August 28, 2025

ADDENDUM 1

City and Borough of Yakutat – Airport Water Extension

AD1.06 C320 – PLAN AND PROFILE – AIRPORT ACCESS ROAD

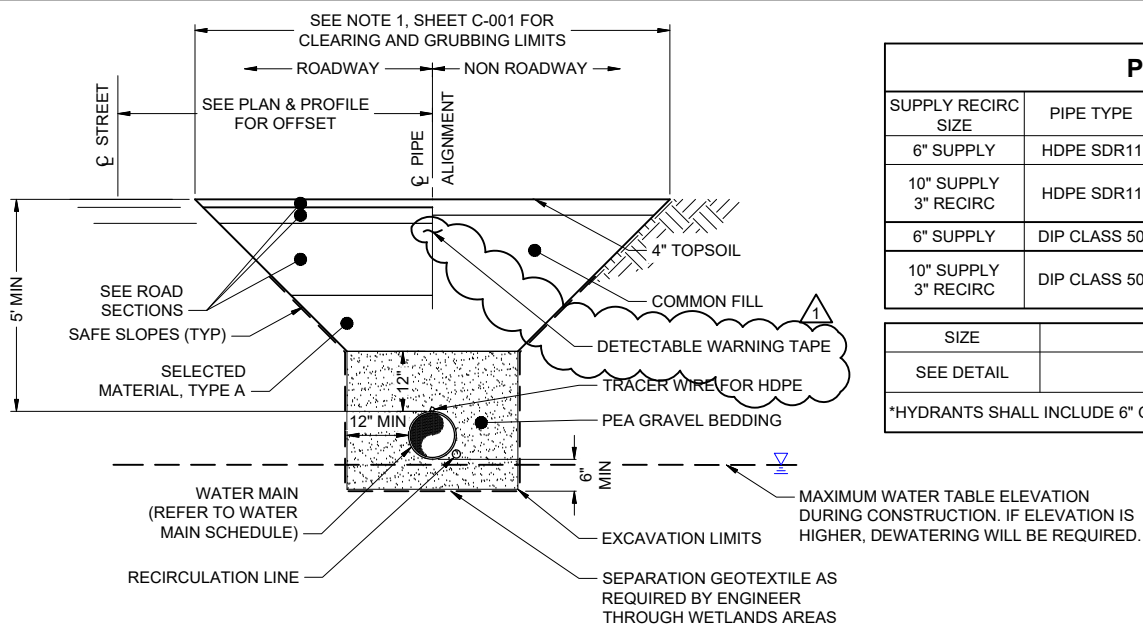
- Updated casing size at STA 230+32 – 231+51 to 12" HDPE
- Updated casing size at STA 235+21 – 236+87 to 12" HDPE

1 TYPICAL TRENCH SECTION

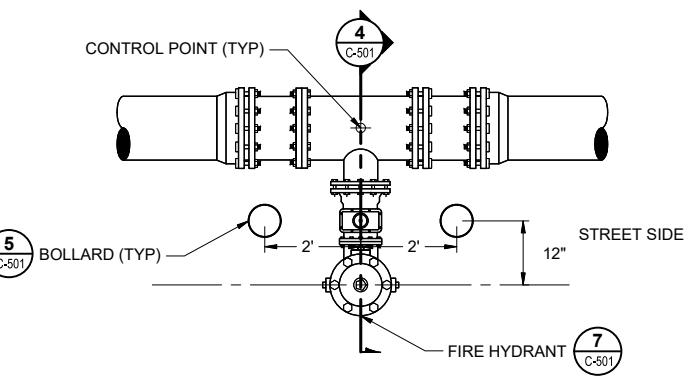
- Updated Detail A to show Detectable Warning Tape for all trenched piping and clarified the tracer wire is only for HDPE piping.
